**Town of Kittery
Planning Board Meeting
May 11, 2023**

ITEM 1 – 77 Bartlett Road – Conservation Subdivision – Sketch Plan Review

Proposal: To subdivide a 19.11-acre parcel into 9 single-family residential building lots, a private street system, and an open space plot around identified wetlands, vernal pools, and a pre-existing cemetery.

SHEET C-3

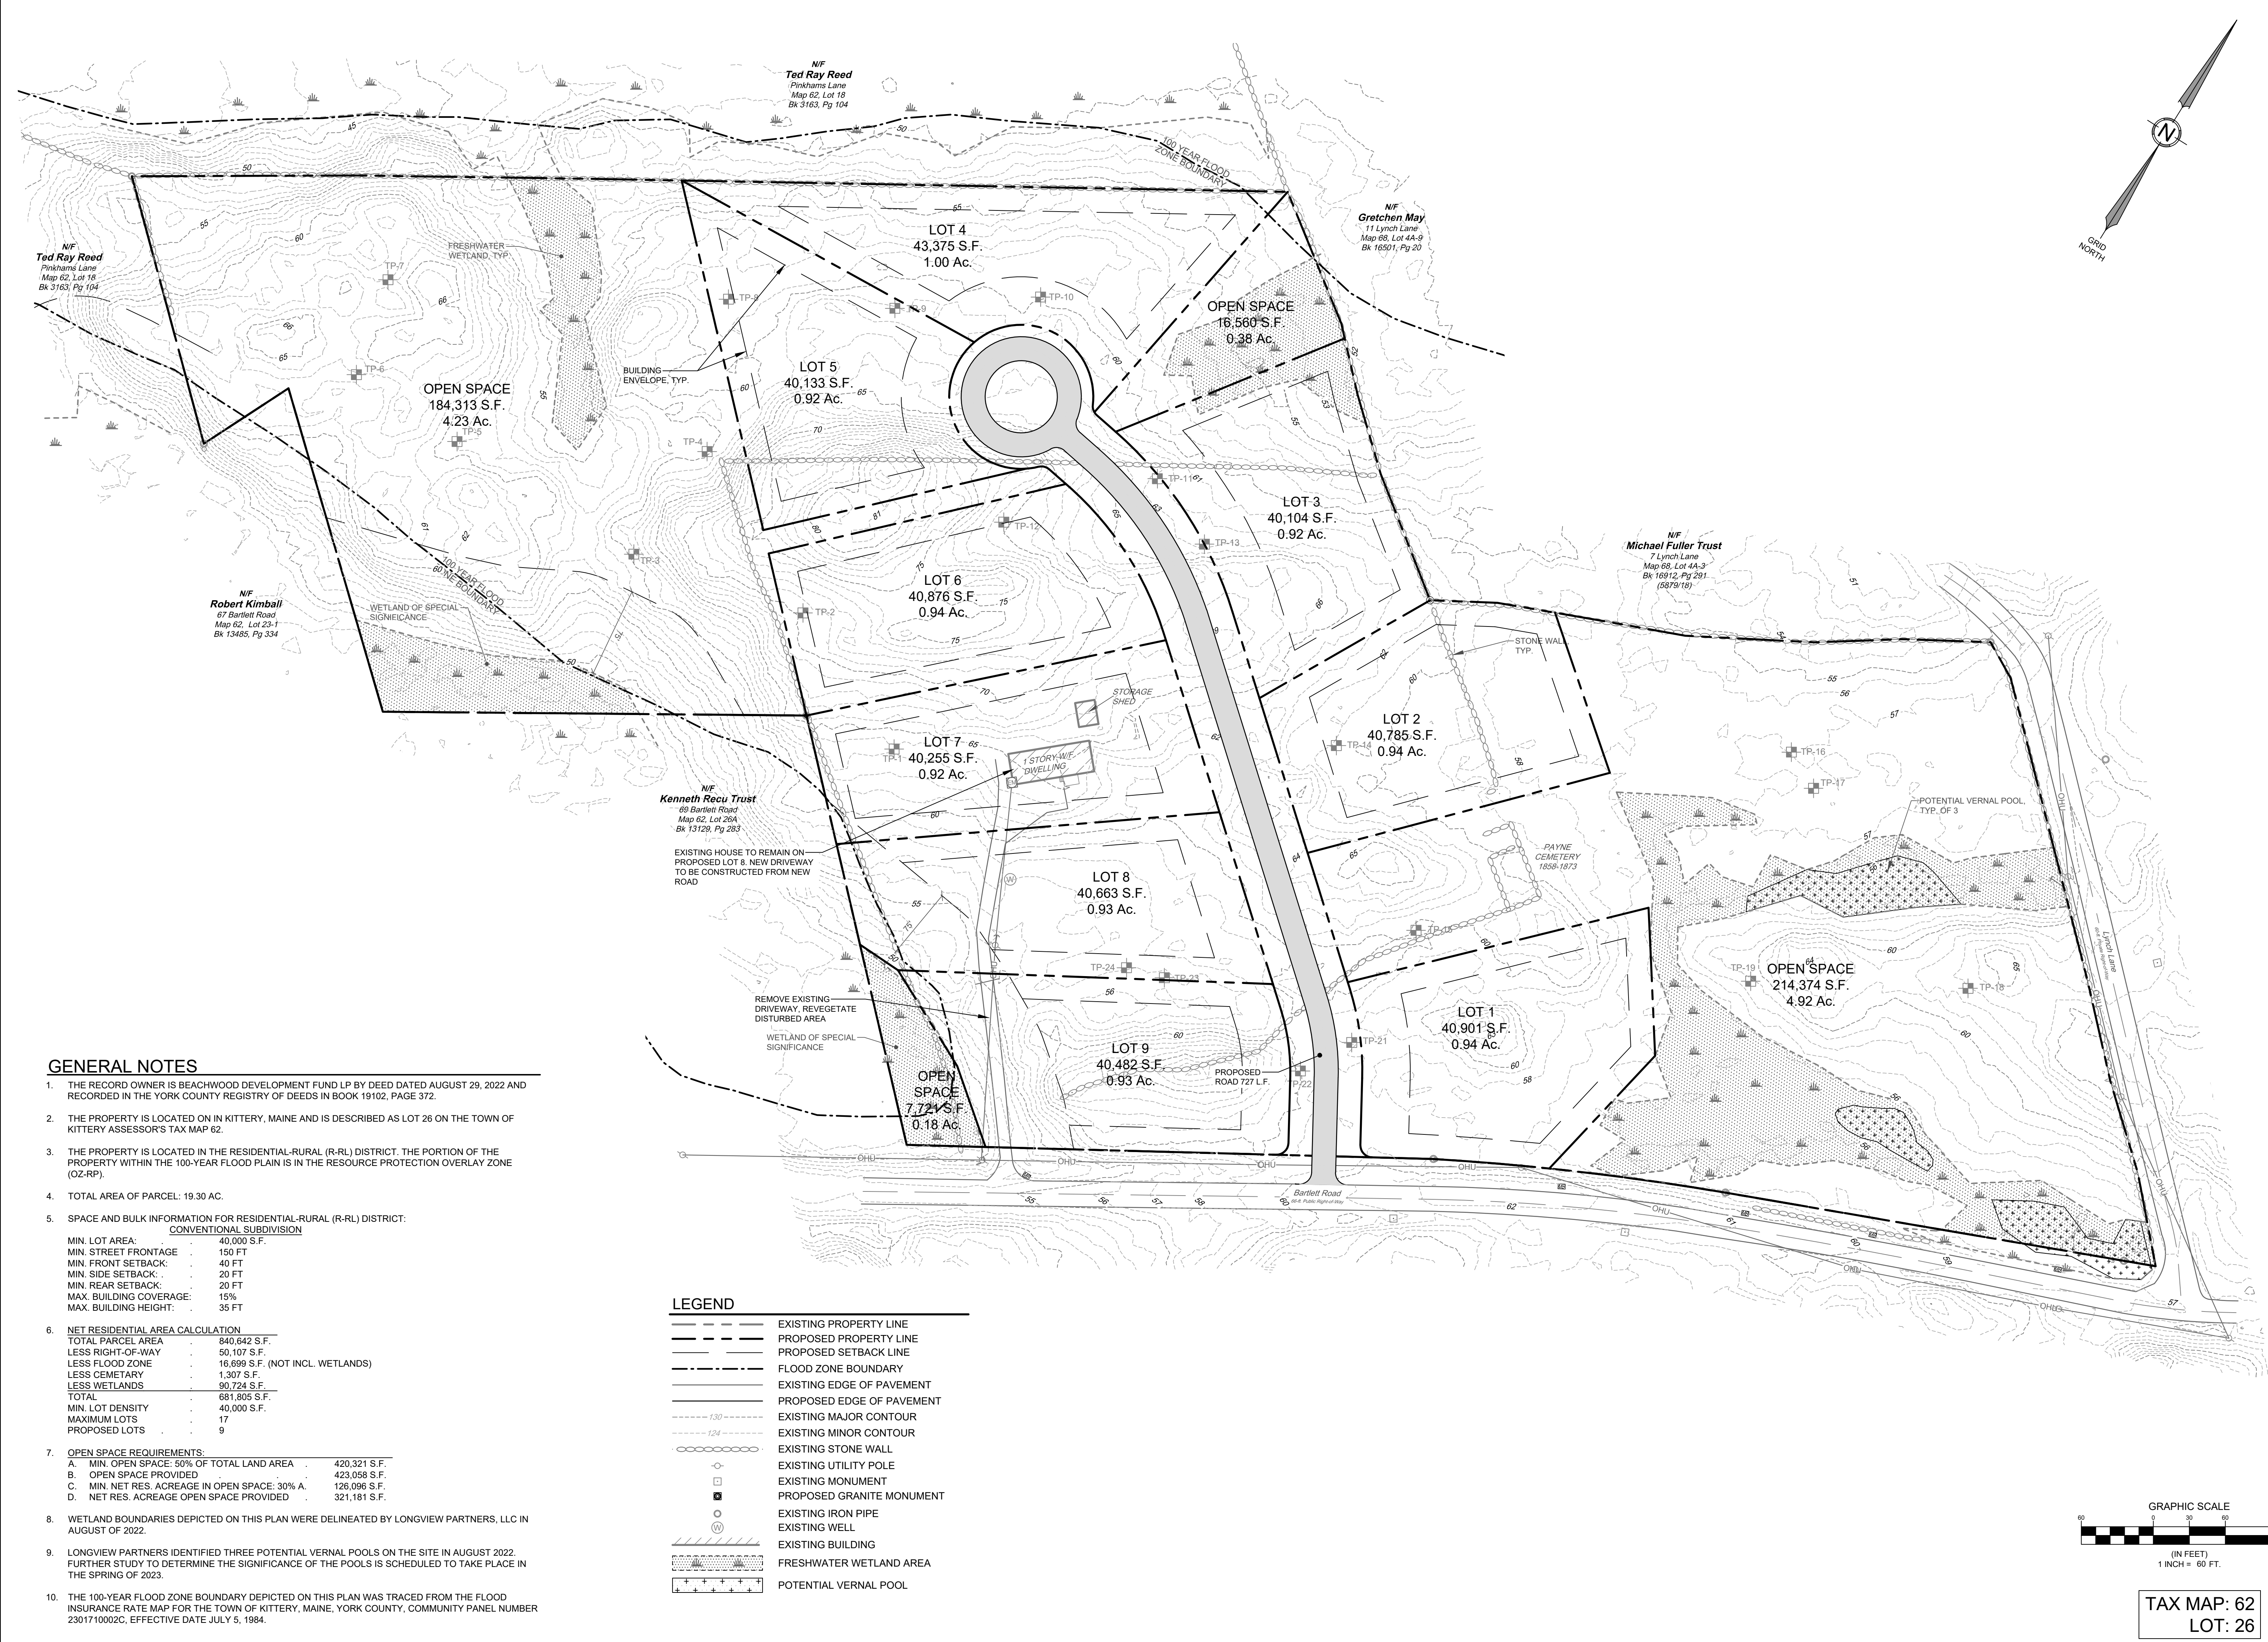
1. The proposal complies with dimensional standards except for a few lots that appear to have street frontage below the 150 feet minimum. Per §16.10.3, the Planning Board can allow flexibility with dimensional standards such as street frontage. Conservation subdivisions are also not required to meet the minimum 40,000 square feet lot size requirement in the R-RL zone.

2. Several lots within the proposed subdivision abut a Resource Protection Zone Overlay; any new construction would be required to be built at minimum 250 feet away from an abutting resource. As currently proposed, lots 1, 8, and 9 would require a “no-cut, no-disturbance” buffer area to provide the recommended 100-foot setback. Given its orientation to the flood zone, lot 7 may also require a buffer zone, but further review is necessary. Wetlands abut the eastern boundary of lot 4 and appear to continue into the neighboring properties of 11 Lynch Lane and 7 Lynch Lane. The size of the wetlands abutting appear to be larger than previously thought.

1. Developers are proposing a 50-foot right of way and 20-foot travel way. The fire department expressed concern about the size of the cul-de-sac, and would like to ensure it is large enough for a truck to turn in. Staff recommended a 40-foot right of way and are waiting for more specific dimensions regarding road size and the radius of the cul-de-sac.

2.The sketch plan currently does not contain the required locations or footprints of the proposed building envelopes for each lot.

1. Developers plan to maintain a vegetated buffer of 40 feet along the front lot line.
2. Lot 4 potentially conflicts with §16.5.14 B-1, which prohibits flag-shaped lots.
3. Because the conservation subdivision ordinance strongly recommends all buildings within the subdivision be designed for maximum energy efficiency and use for heating and, it is suggested that buildings be designed as south-facing whenever possible in this subdivision.

2. Significant wetlands on the eastern portion of the property are being protected as open space. As mentioned above, lots 1, 8, and 9 will require a no-cut, no-disturbance buffer to maintain the recommended 100-foot setback from each relevant resource, and lots 4 and 7 may also require buffers after further review. A potential vernal pool has been identified in the eastern portion of the parcel. While testing is currently underway, the area of the potential vernal pool is within the land currently designated for open space and will not be subject to development in the proposed plan.
